3-K-21-HZ
APPLICATION FOR CERTIFICATE OF APPROPRIATENESS

1319 Grainger Ave. 37912
Old North Knoxville H

Original Print Date: 5/5/2021
 Knoxville/Knox County Planning -- Historic Zoning Commission

Level 2 scope of work, for HZC review 5.20.2021: Proposed replacement of three porch columns: two corner columns on the first-story porch (east and west) and one leftmost (west) corner column on the second-story porch. Two-story porch features six round fluted columns on the first story and five round fluted columns on the second-story porch. Due to water intrusion from weather, failing gutters, and adjacent large trees, three corner columns have rotted. Applicant is proposing the installation of fiberglass reinforced polymer columns instead of wood. On the first-story porch, round fluted columns will measure 9' overall in height and 12" in diameter, with a slight taper to match the existing columns. On the second-story porch, columns will measure 8' overall in height and 10" in diameter. Columns will be smooth-finished on top of square base. Historic capitals to be retained, repaired, and installed on top of new columns. Historic wood railing to be retained.

2 proposed replacement columns for left and right corners on porch

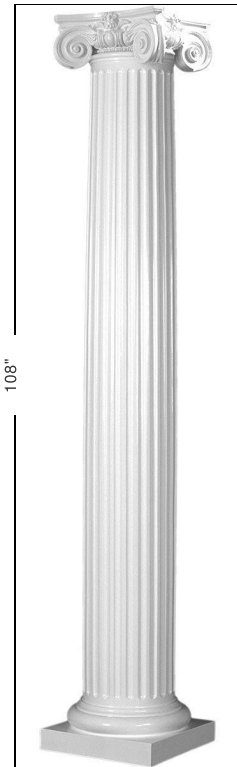
5. Due to significant deterioration on the corner columns, the applicant is proposing replacement of the corner columns on the first story (east and west), and the west corner column on the second story. Due to the location of the corner columns and their exposure to the elements, the applicant is proposing an alternative material to hollow wood columns.

6. The proposed material is FRP (Fiber Reinforced Polymers), aka fiberglass. NPS Preservation Brief 16, "the Use of Substitute Materials on Historic Building Exteriors," [see attached] notes that FRP is produced as a thin rigid

9. NPS Preservation Brief 16 notes that "in order to provide an appearance that is compatible with the historic material, the new material should match the details and craftsmanship of the original as well as the color, surface texture, surface reflectivity, and finish of the original material."

- 1) retain and reinstall existing railings; retain, repair, and reinstall original capitals; and install bases with placement, dimensions, and design to match existing;
- 2) replacement columns be confirmed to match size, taper proportions, fluting detail of wood columns;
- 3) confirmation of color, surface texture, and reflective surface to be compatible with the existing columns;
- 4) information to be provided to staff on column ventilation to minimize expansion/contraction issues which could negatively affect the original capitals.
